To: T10 Technical Committee
From: Rob Elliott, Compaq Computer Corporation (Robert.Elliott@compaq.com)
Date: 16 April 2001
Subject: SPI-4 negotiation message rewrite

Overview

Figure 2. Initiator originated PPR negotiation: initiator response to target responses to PPR OUT

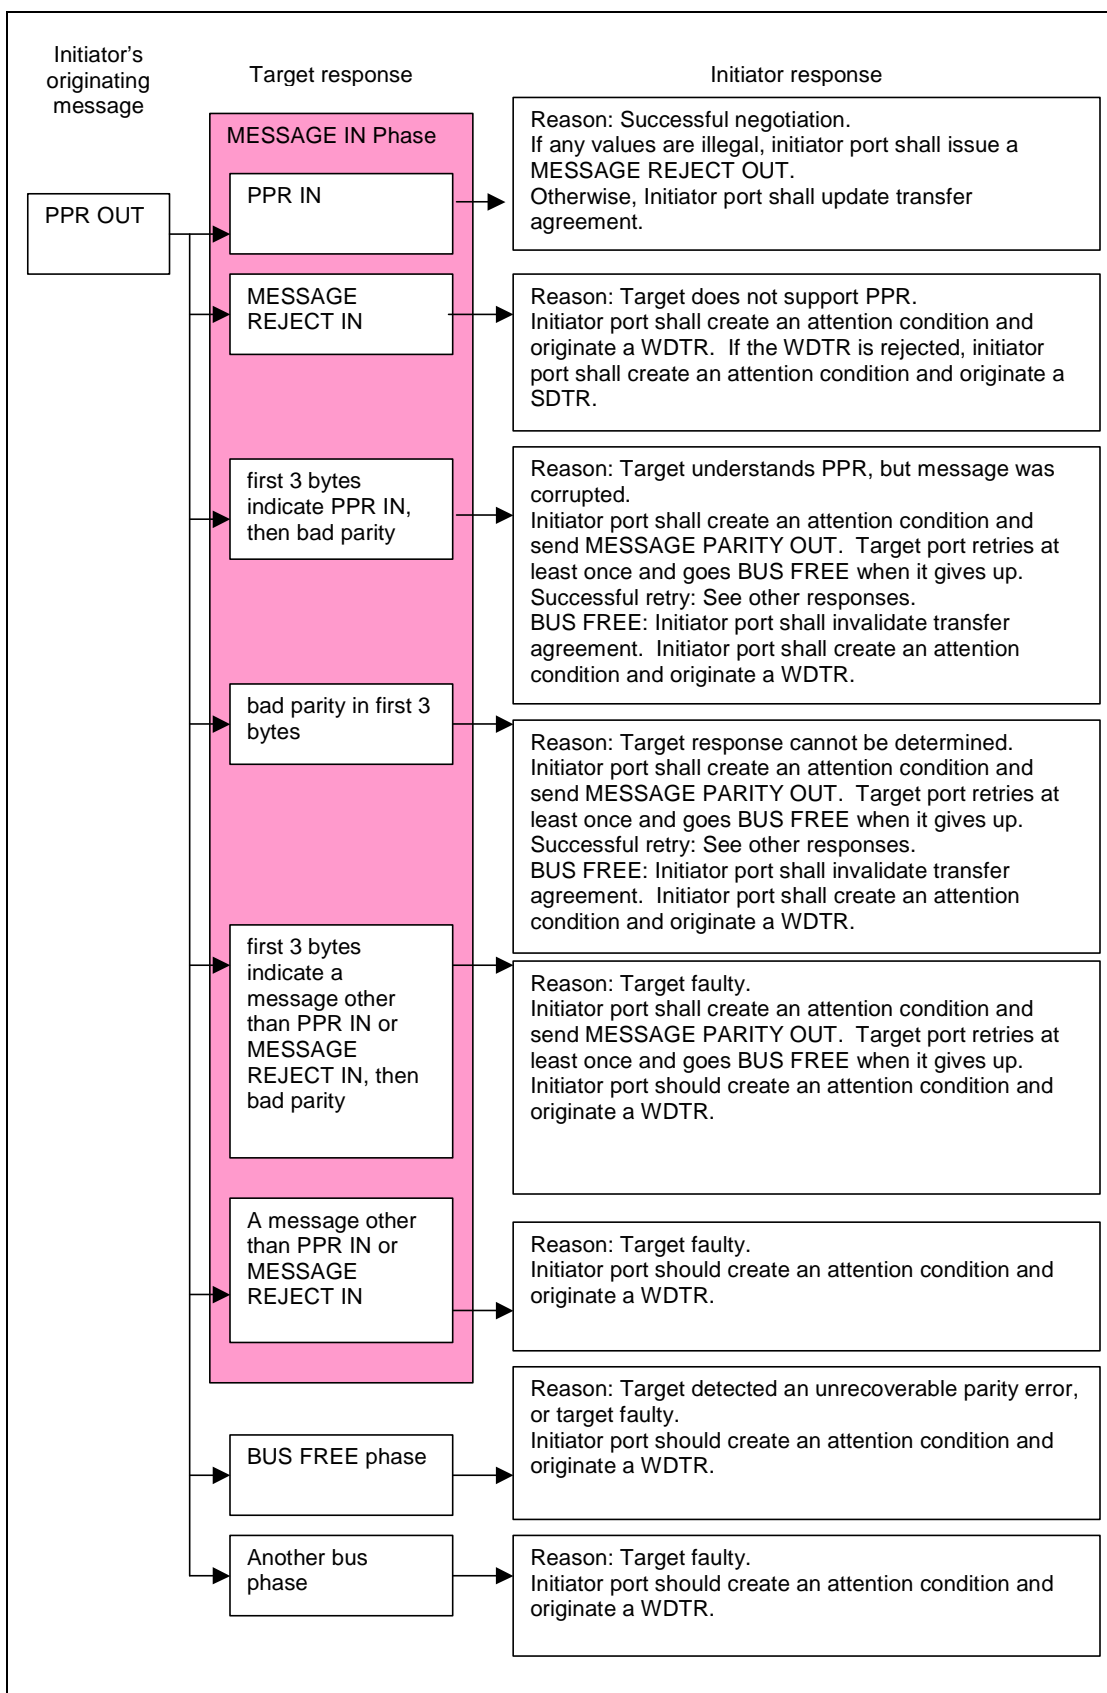
[Editor’s note: this is the difficult section. The initiator and target each have different views of the state of negotiation. When one side sends a message, the other side may receive it, or may receive a parity error on any byte.

If the originating message went bad, the responding message won’t be a valid negotiation message, so the originator knows the responder did not receive it correctly. For example, a PPR OUT won’t be followed by a PPR IN unless the target was happy with it.

However, if the originating message is fine but the responding message is bad, the two sides start to have trouble determining whether to maintain their settings, invalidate them (and negotiate again with an older message), or go to async mode. It’s not always safe to drop to async mode – the other side might not have done the same.

Figure 2 shows how the initiator shall respond to various target responses to a PPR OUT. The initiator port shall maintain the previous transfer agreement unless otherwise indicated.

Figure 3. Initiator originated PPR negotiation: target response to initiator responses

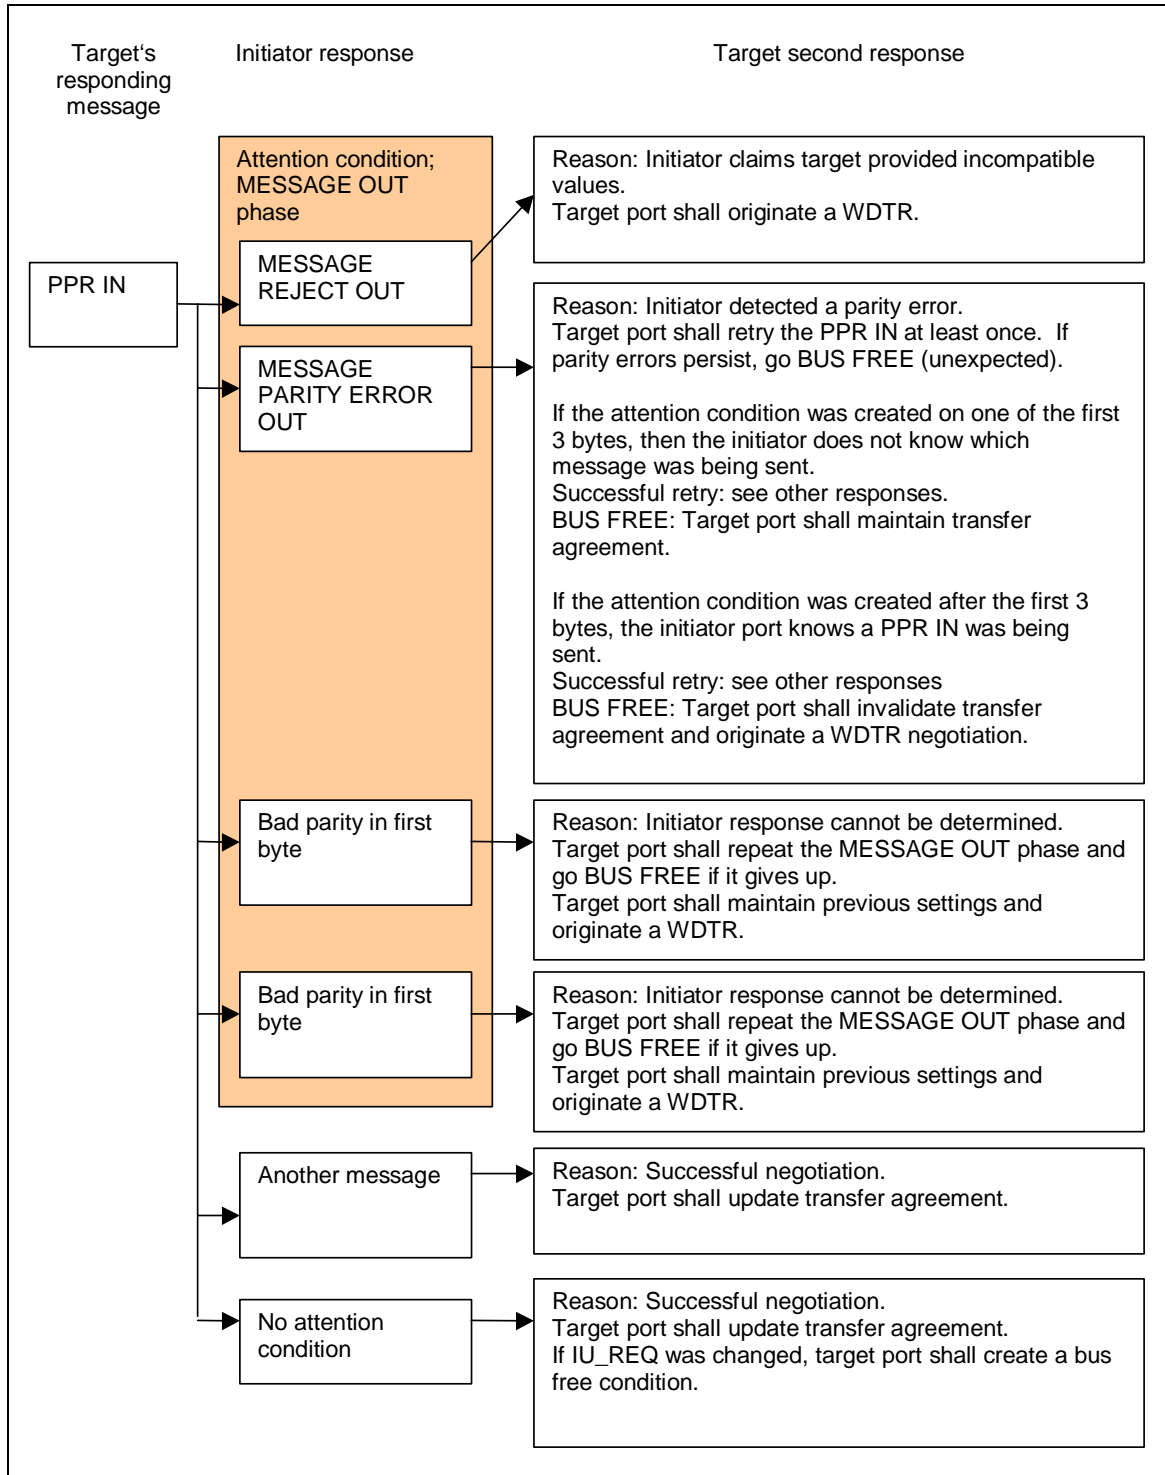
Figure 3 shows how the target shall respond to various initiator responses. The initiator port shall maintain the previous transfer agreement unless otherwise indicated.

[Editor's note: The WDTR OUT sequences that follow are shown in table format. Which is preferred, table or figure? I think the figures are clearer.]
